# Proyecto de Modernización de la Refinería de Talara

Evaluación y opinión sobre configuración técnica y dimensionamiento del FEED

*Informe Final*

### Critical Design Aspects – Production Mix

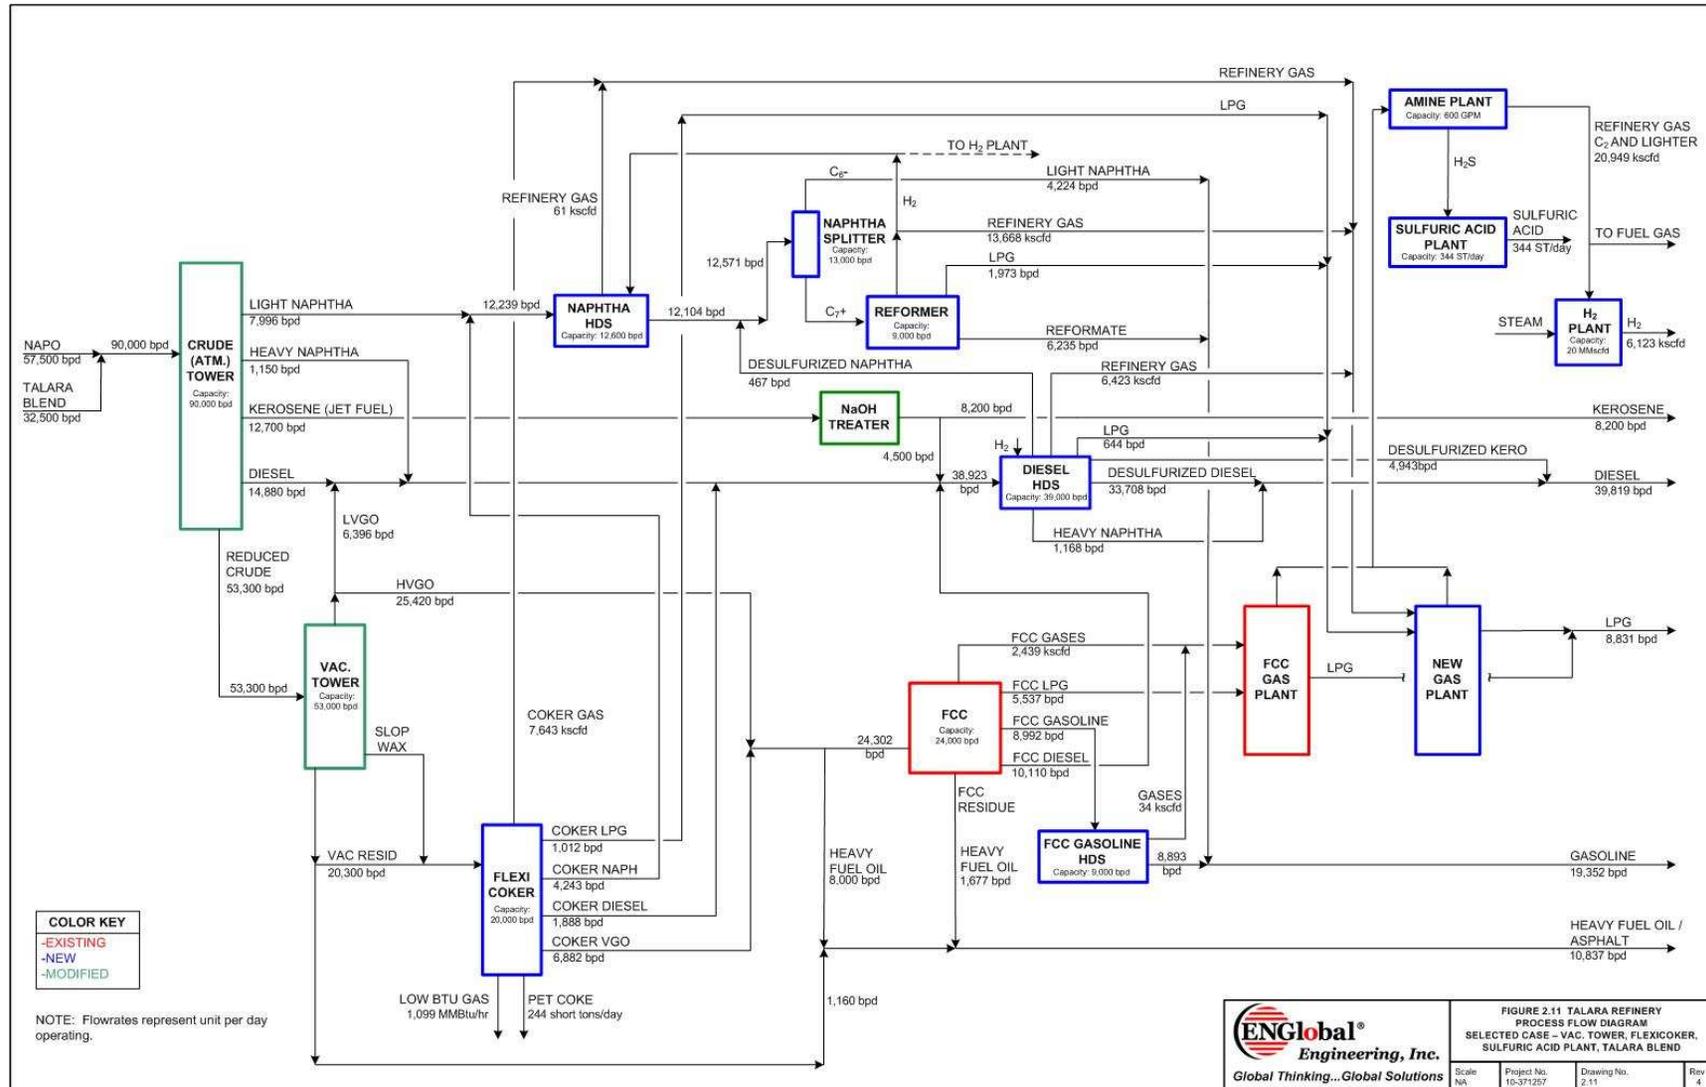
**FEED production design converts a higher percentage of heavy hydrocarbons, producing a slightly higher portion of medium distillates and gasoline. Coke production has been significantly decreased**

Product	Unit	CE	% in WT	FEED	% in WT	ADL View on Change
GLP	BPSD	9,296	6%	4,900	4%	<p>The FEED has higher carbon content of the crude oil, and heavier and higher sulfur content crude mix as the feedstock. FEED design adds complexity and severity to convert a higher percentage of heavy hydrocarbons.</p> <p>This implies a larger portion of sulfur to be removed from lighter streams with higher capacities needed at sulfur related units like Amine, Hydrogen and Sulfuric Acid.</p>
Butane	-		0%	1,660	1%	
Gasoline	BPSD	20,371	19%	21,400	21%	
Turbo	BPSD	8,632	9%	6,157	6%	
Diesel	BPSD	41,980	43%	43,700	48%	
High Sulfur Residuals	BPSD	7,522	11%	8,900	11%	
Asphalt	BPSD	3,885	5%	500	4%	
Sulfuric Acid	TN/D	362	3%	560	5%	
Coke	TN/D	514	4%	126	1%

### FEED's Overall Refinery Block Flow Diagram

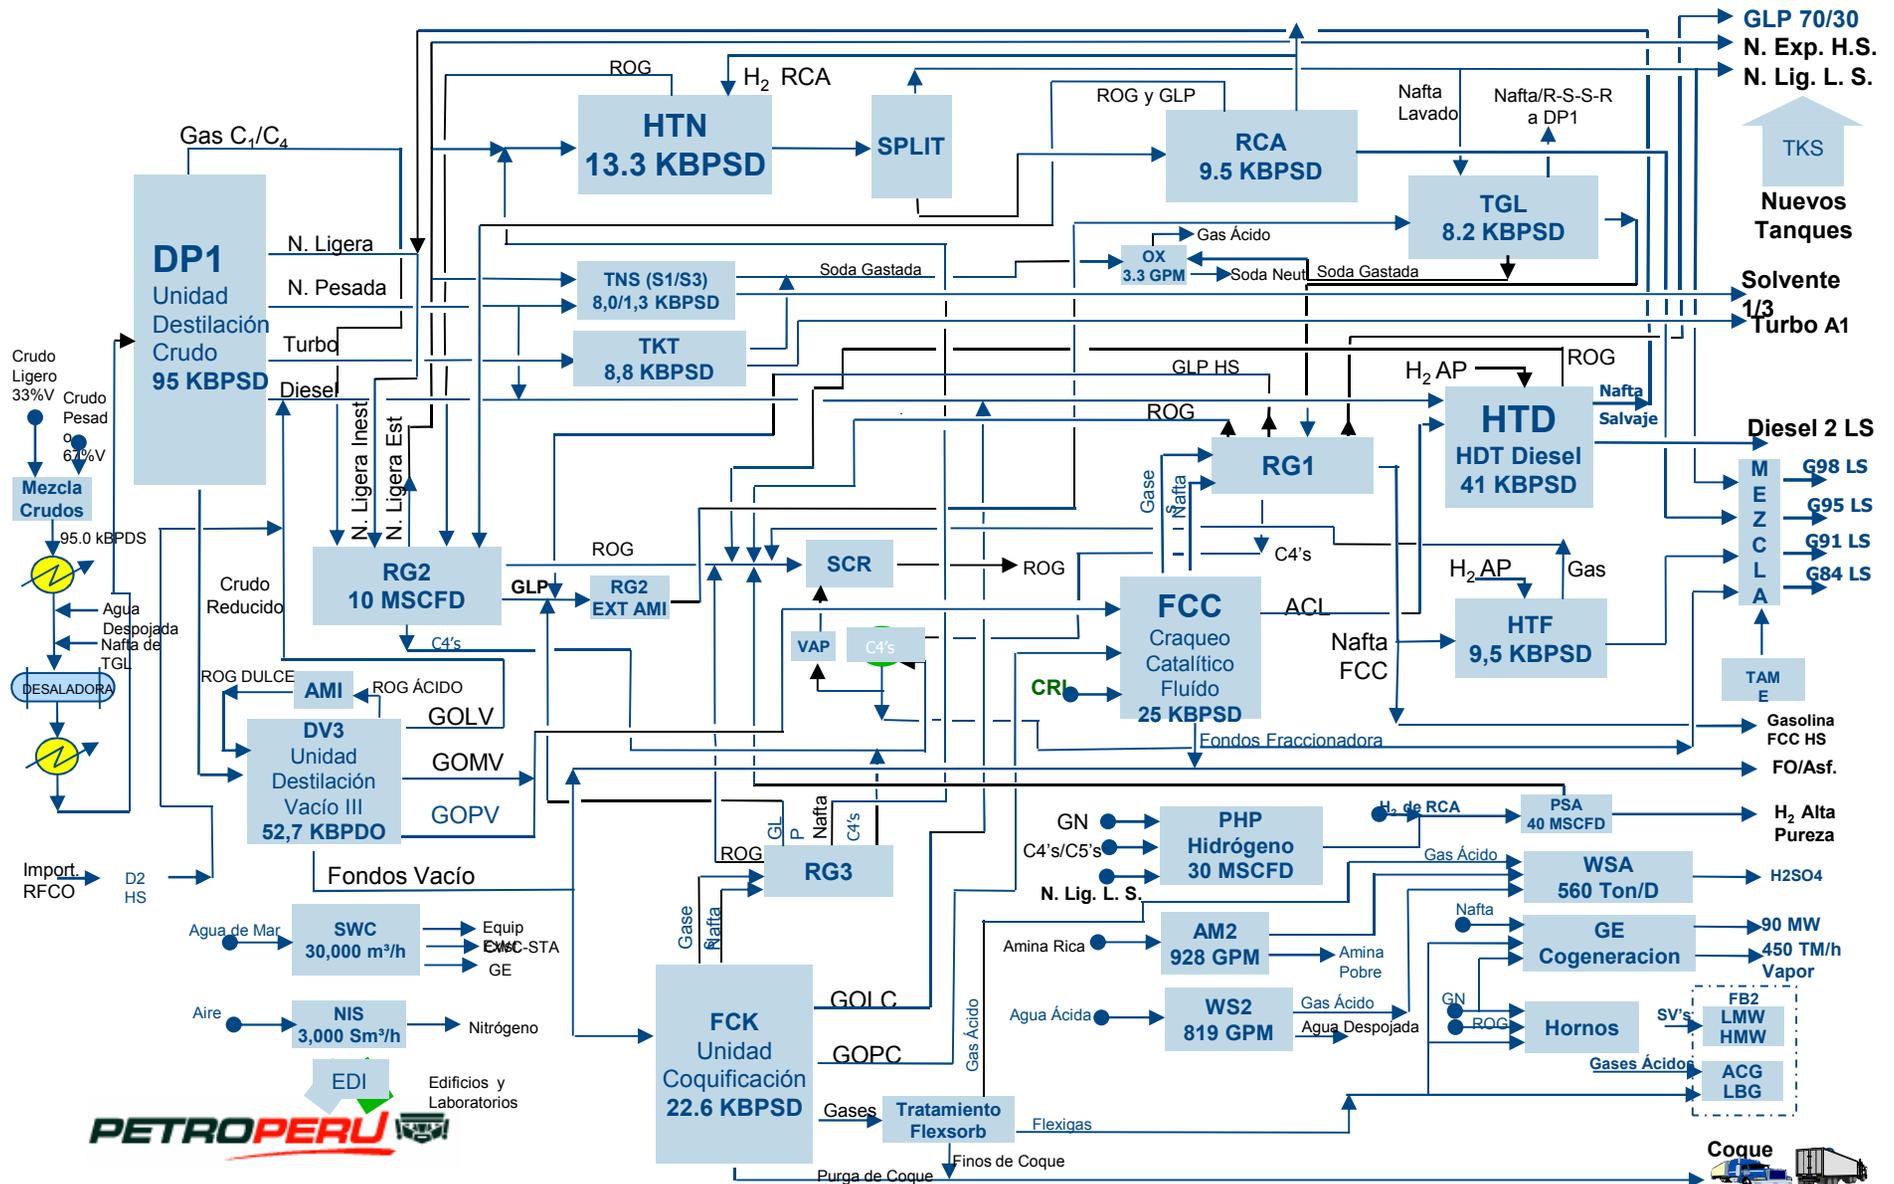
**FEED design did not change much the size of main process units, but there are significant changes on those related to sulfur content and hydrogen, and utilities**
